**HISTORIC PRESERVATION COMMISSION MEETING
AGENDA**

Thursday, October 15, 2015 at 7:00 p.m.
Municipal Building, 26 Union Street, South

Certificate of Appropriateness Request : H-13-15

Certificate of Appropriateness Request : H-20-15

Fence Location
 Exhibit C

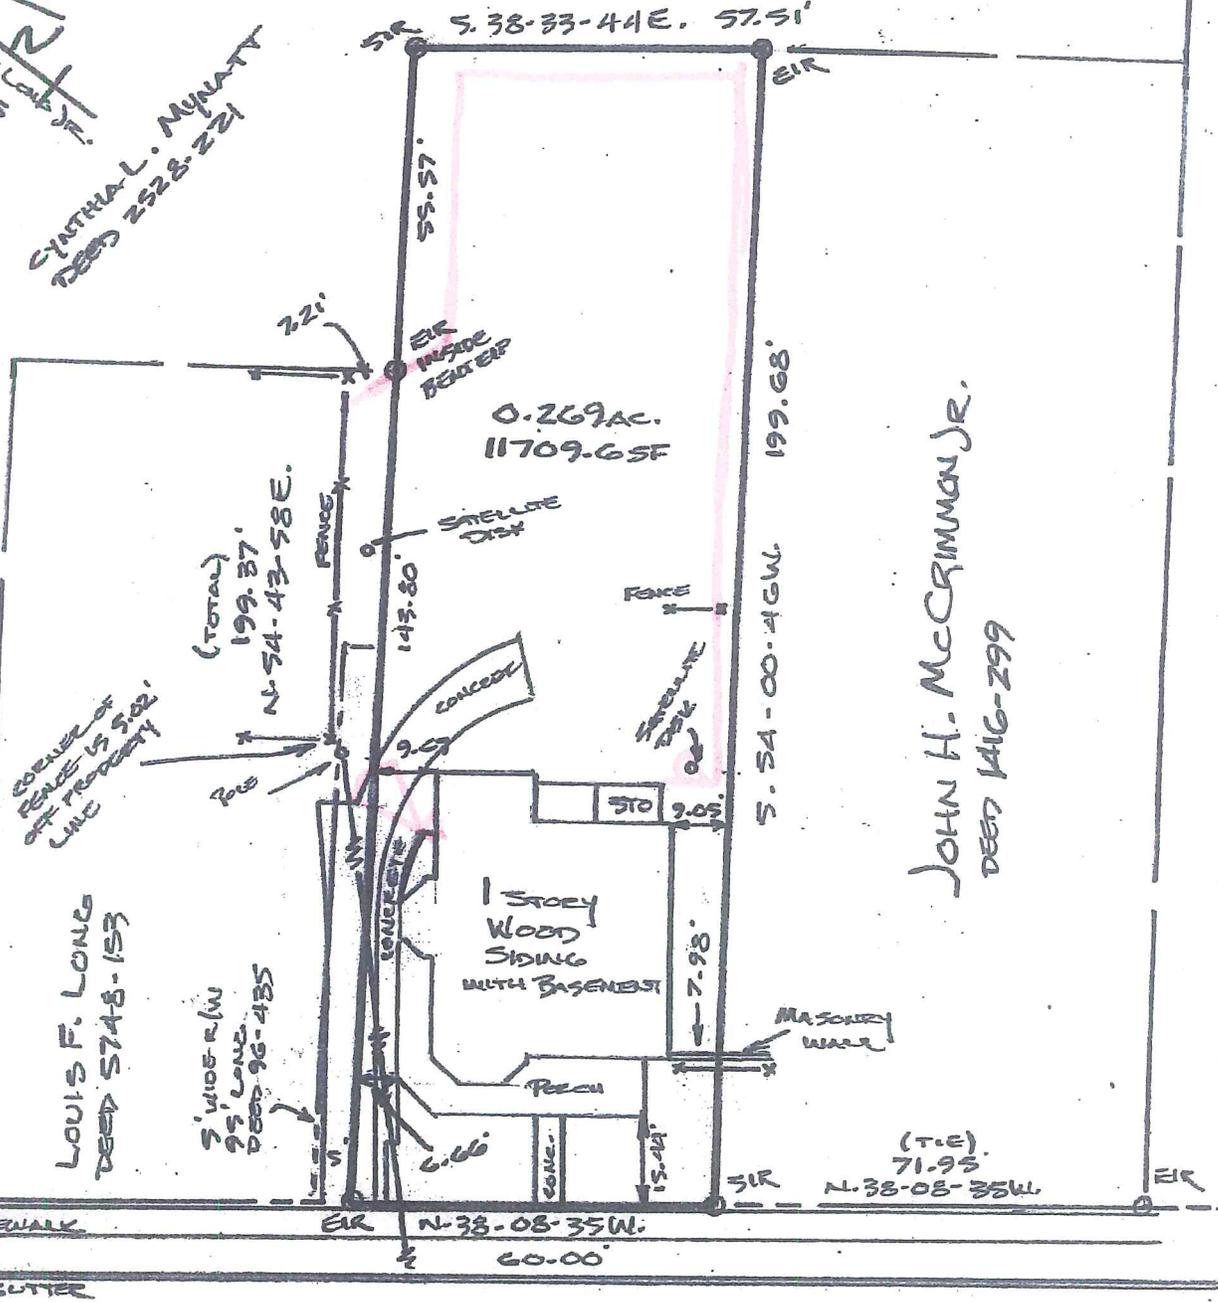
The applicants have submitted a request to install a black powder coated aluminum fence in the rear yard. A site rendering (Exhibit C) showing the location of the proposed fence and illustrations (Exhibit D) demonstrating the style and design have been submitted. As shown on the product sheet, the fence style chosen by the applicants is called "Granite." This fence style is approximately 4ft tall, with 4in between pickets, and three horizontal rails including a flat rail top. The site rendering shows the fence running parallel to the rear and side property lines. The fence also crosses the property line at an angle between the primary property of 183 Union St. South and connects to an existing fence on the property located at 179 Union St. South. The owners of both properties have agreed to the fence location by signing the submitted application (Exhibit B). Three gates are proposed for the fence. As shown on the site plan (Exhibit C) two single swinging, pedestrian gates are proposed on both sides of the fence that attach to the rear of the residence. The gate on the left side (facing the home) is shown to be 3ft wide and the gate on the right side (facing the home) is shown as 4ft wide. Additionally, a 9ft wide, single swinging, vehicular access gate is also proposed on the left side (facing the home) across the existing driveway. 299ft linear feet of fence and gates are proposed to be installed across the subject properties.

Handbook Section - Chapter 5 – Section 9: Rear yard fences are defined as fences, which do not extend forward on the applicant's property beyond the side centerline of the house in plain view. Approval of the location may also be handled on a case-by-case basis to determine the best natural break in the rear and front yards for placement of fences. Rear yard fences may be higher than four feet.

Matthew and Kristina Dugan have submitted a Certificate of Appropriateness application in order to install a fence in the rear yard of the property located at 183 Union Street, South that will cross over the property line to connect with an existing fence located at 179 Union Street, South. PIN's 5630-06-3613 and p/o PIN 5630-06-2656 **APPROVED WITH CONDITIONS**

1 PROPOSED CARPORT FLOOR PLAN
 A-3 3/16" = 1'-0" 435 SF

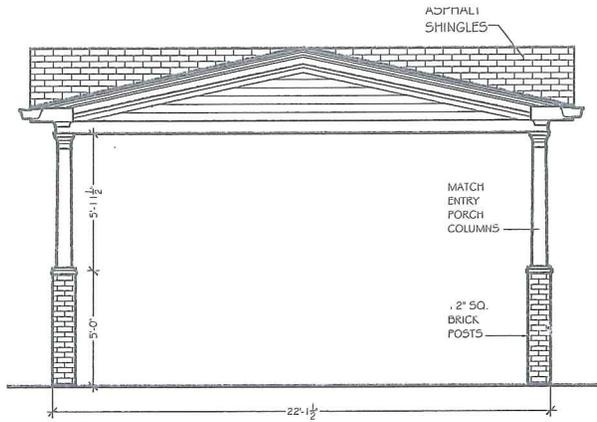
Carport: As shown on the site plan, the new carport is proposed to be approximately 18ft wide by approximately 21ft long. It is proposed to be adjacent, but not attached to, the left side elevation (facing the rear of the home). The gabled carport roof is shown to extend to the existing rear entrance and walkway. An additional gabled roof is proposed to be extended, from the existing, over the walkway, connecting to the new carport. The existing entrance columns will remain and a total of 7 new columns are proposed. Each includes a 5ft tall brick base and 6ft tall round/Tuscan inspired column to mimic the existing. The wood siding and asphalt shingles that match the existing are also proposed on carport.

PIN 5620-89-1124 **APPROVED WITH CONDITIONS**

1 PROPOSED REAR ELEVATION
 A-5 1/8" = 1'-0"

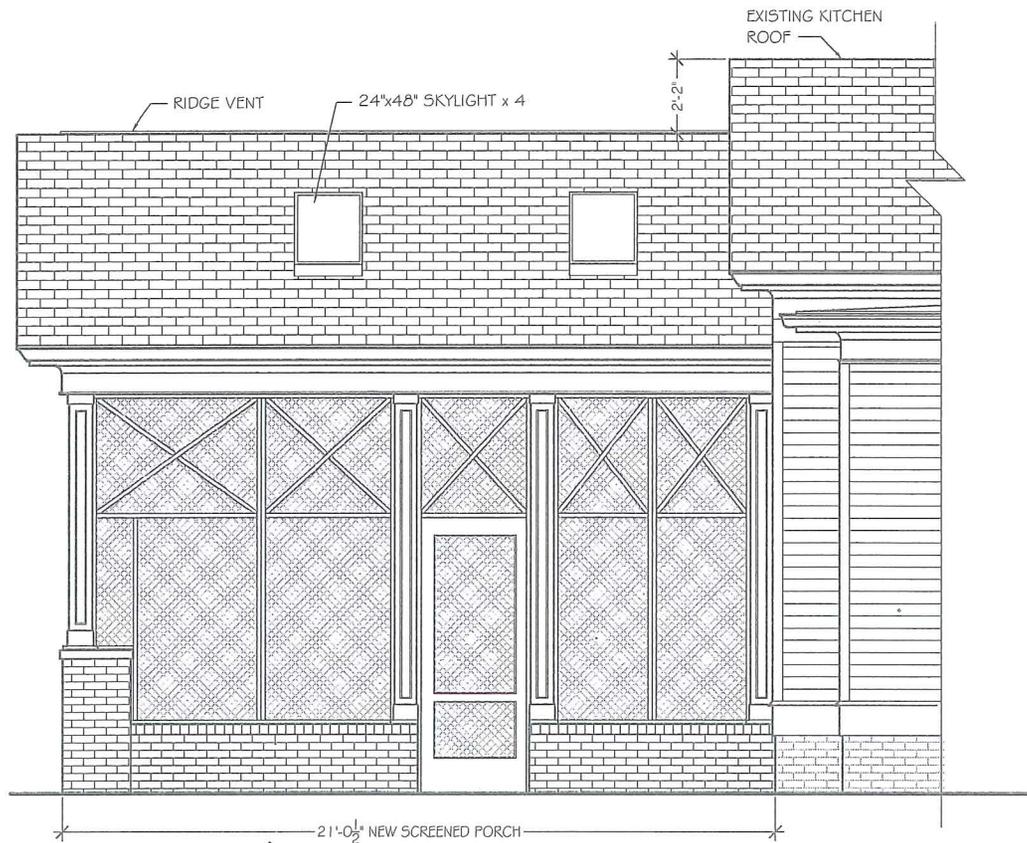
Screened Porch: As shown on the site plan and elevations, a new screened porch is proposed to be attached to the right side rear elevation (facing the rear of the home) atop the existing brick patio. The proposed screened porch would be approximately 18ft wide by 20ft long and would feature a gable roof, mimicking and extending from the existing. The gable vent would be relocated and repurposed to maintain consistency of the existing design. Four new skylights are proposed on both sides of the gabled roof to allow more light in the new screened porch. The addition is designed with 10 new decorative square columns, each with a brick base, connected by screening. Square columns were chosen for this project due to the connecting screen. Three entrances are proposed for the screened porch, with one being on each side. The entrances on the left and right sides (facing the rear of the home) are single swinging and approximately 36inches wide. A 20in double swinging screen door is proposed for the rear side elevation, including two new brick steps leading up to the doorway. As a part of the screened porch project, a small brick wall would be added, including columns, surrounding the patio for consistency. Also, a new outdoor grill and grill shelter are planned. This structure would also consist of brick, square wooden columns and asphalt shingles.
